# CITY OF COCONUT CREEK

# DEVELOPMENT REVIEW COMMITTEE REVIEW #3 FEBRUARY 11, 2013

Project Name: Saw Palmetto Natural Area

Project Number: PZ-12090001

SAW PALMETTO NATURAL AREA LANDSCAPE PLAN AND DETAILS

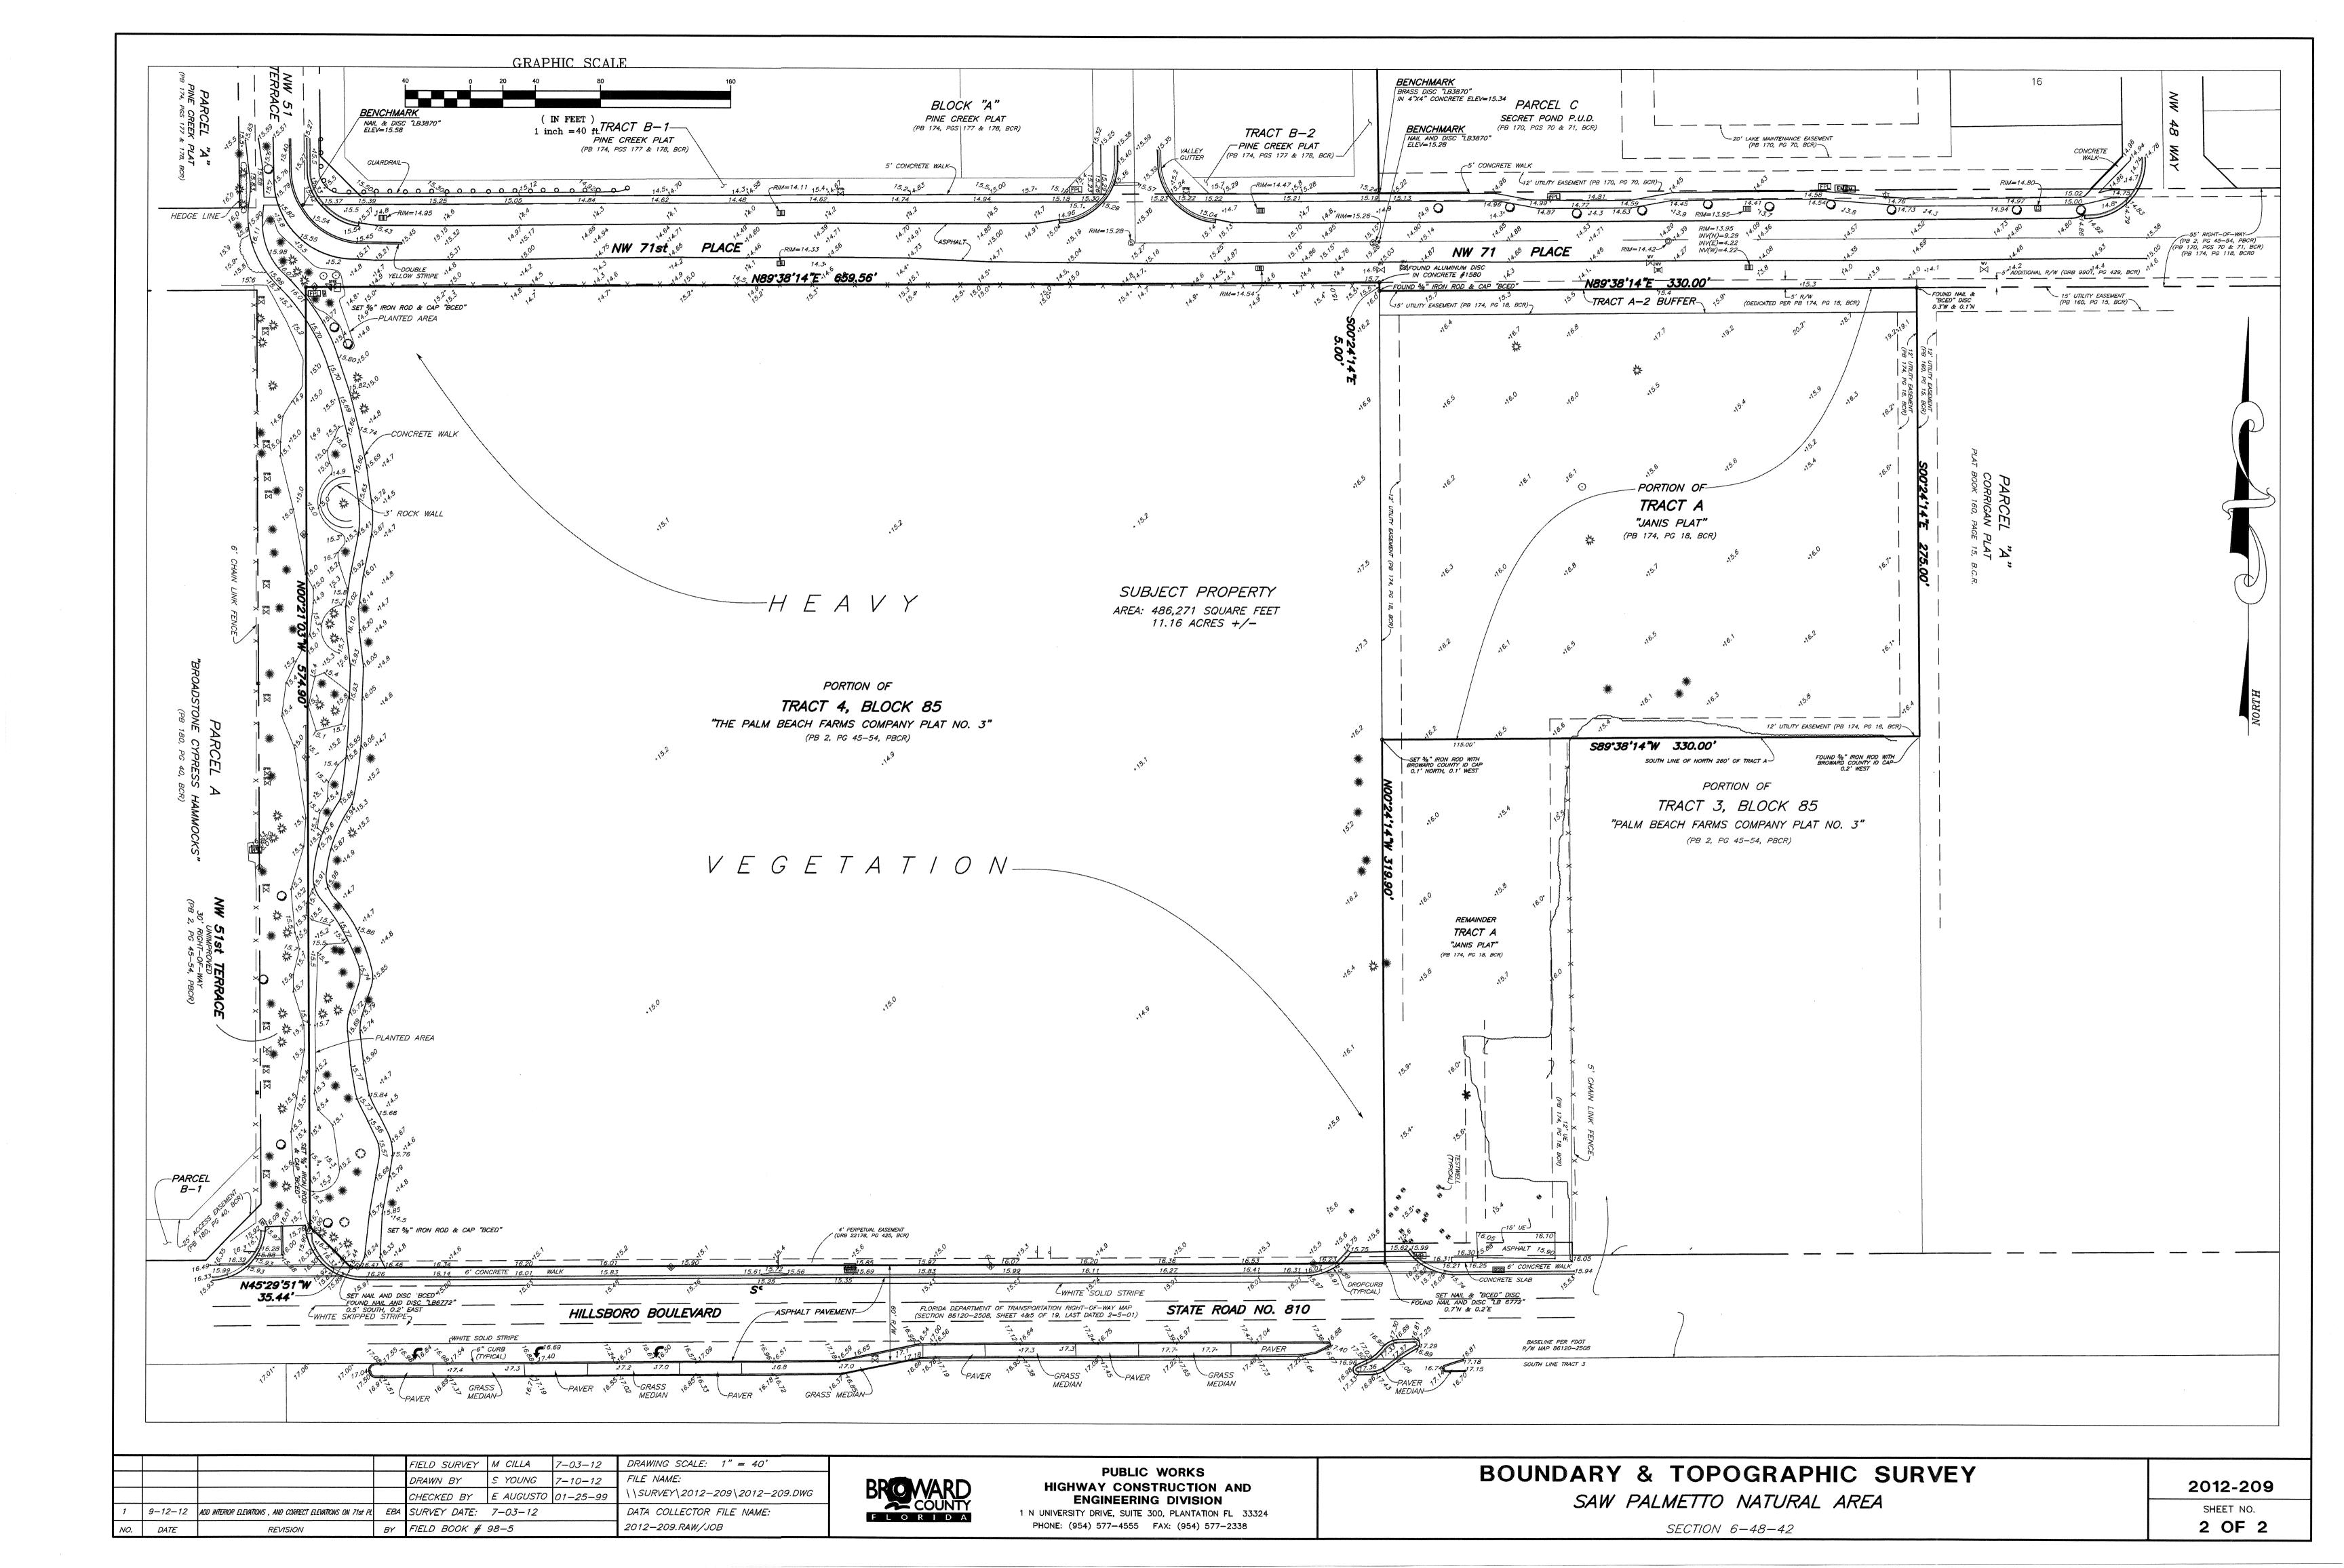
- 1. Continuous visual screen around irrigation pump requires "branch to branch spacing". The plant material specified has a spread of 18", which would require an on center spacing of 18". Revise spacing on the plant list and revise plant quantities.
- 2. Fire Hydrant detail requires 7.5' in front of its location, detail shows 4'. Revise detail accordingly.
